**SOLICITATION AMENDMENT
MODIFICATION DE L'INVITATION**

Title - Sujet Furniture	
Solicitation No. - N° de l'invitation M5000-197162/A	Amendment No. - N° modif. 003
Client Reference No. - N° de référence du client M5000-197162	Date 2019-08-13
GETS Reference No. - N° de référence de SEAG PW-\$WPG-006-10869	
File No. - N° de dossier WPG-9-42049 (006)	CCC No./N° CCC - FMS No./N° VME
Solicitation Closes - L'invitation prend fin at - à 02:00 PM on - le 2019-08-28	Time Zone Fuseau horaire Central Daylight Saving Time CDT
F.O.B. - F.A.B. Plant-Usine: <input type="checkbox"/> Destination: <input checked="" type="checkbox"/> Other-Autre: <input type="checkbox"/>	
Address Enquiries to: - Adresser toutes questions à: Graham, Danielle	Buyer Id - Id de l'acheteur wpg006
Telephone No. - N° de téléphone (204) 292-2872 ()	FAX No. - N° de FAX (204) 983-7796
Destination - of Goods, Services, and Construction: Destination - des biens, services et construction: Royal Canadian Mounted Police K Division Headquarters 11140-109th Street Edmonton, AB T5G 2T4

This **amendment # 003** is raised to respond to bidder's questions and modify **solicitation # M5000-197162/A** as follows:

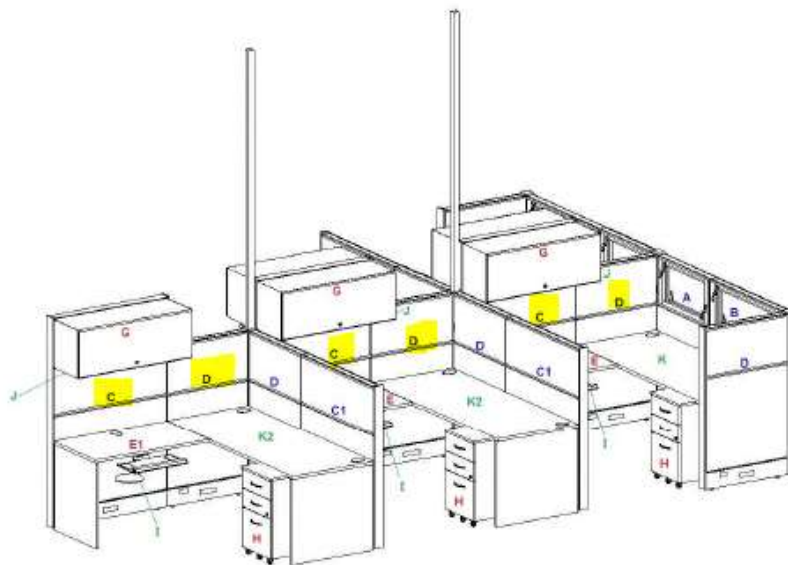
Annex C Floor Plan(s), Category 1A Panel C is noted as having Powered Outlets and Panel D is noted as Non-Powered. The provided drawings appear to show Panel D as having Power and Panel C as being Non-Powered. Please confirm the panels that is to be powered. Can you note the requested power locations on the drawings?

Only Panel C is to be powered. Panel D is to be non-powered.

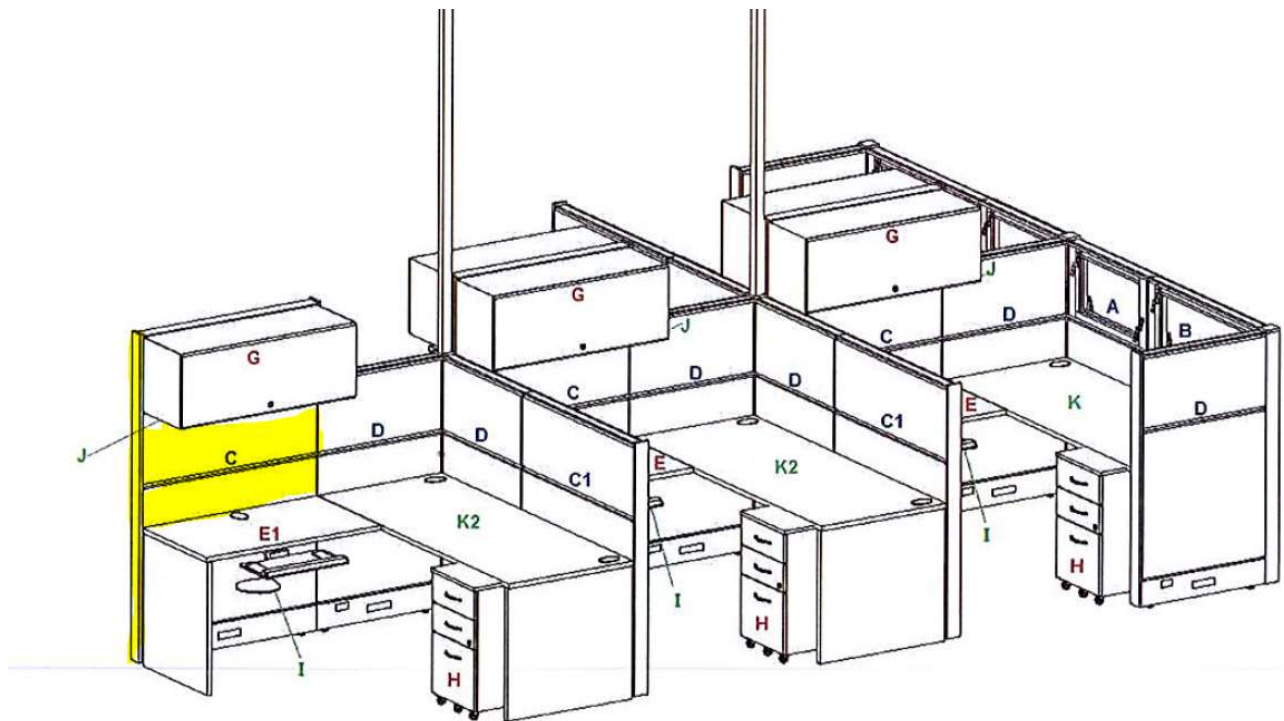
C "Seated Privacy Height" requested and is approx 51"h. Can you confirm where overhead is located the requested height is "standing" height privacy vs seated?

Yes, 'C' panel, where the overhead storage is located, needs to be standing height.

C	Standing Privacy Height Add On Powered outlet(s) Below Work Surface / Prise(s) électrique(s) au dessous de la surface de travail Lower Element, Élément inférieur 1 & 2: Fabric / tissu Upper Element, Élément supérieur 1&2: Tackable Surface / surface punaisable 42"W
----------	--
